RE: NOI Supplemental Information Lot 8A Andersen Drive Boxford, MA

Applicant: Donald Gianquitto DEP File #114-1306

Plan Revisions

Crossing Redesign - Compliance with Massachusetts Stream Crossing Standards

2018 の子づいたののひびらえがたのながに向って、しょ CROSSING SAMPLE BOX CULVERY

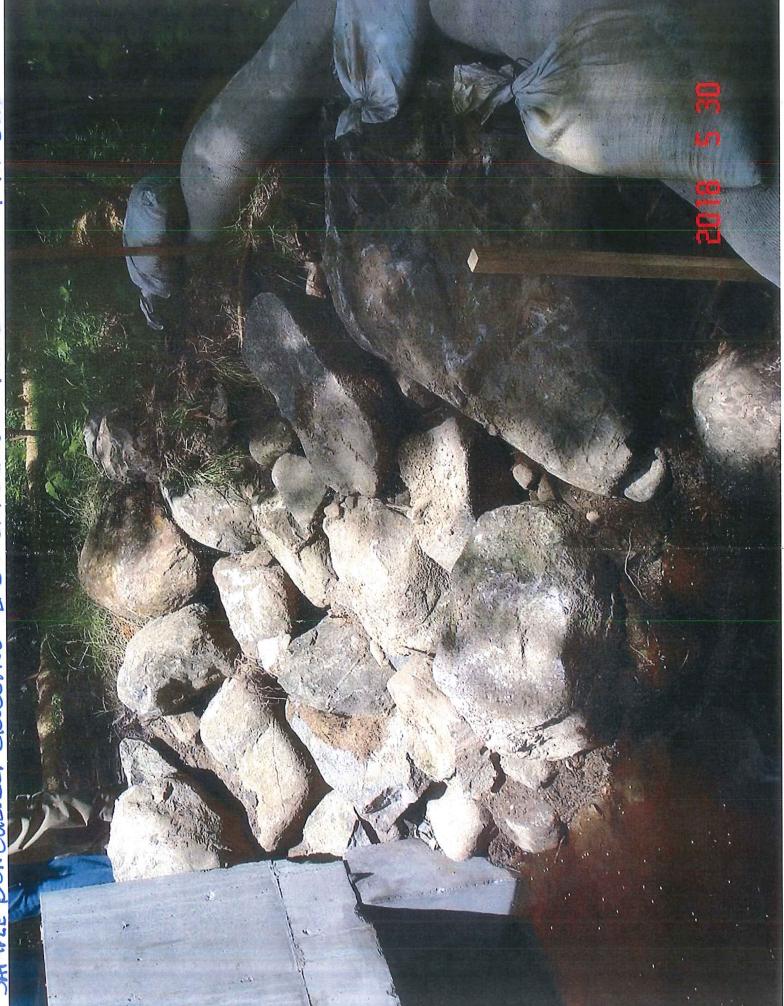
The proposed box culvert crossing detailed on the revised Notice of Intent plan is similar to the 2018 driveway crossing at #57 Candlewood Drive in Topsfield, MA designed by Hayes Engineering, Inc. Photographs of that completed culvert crossing are attached for the Commission's consideration.
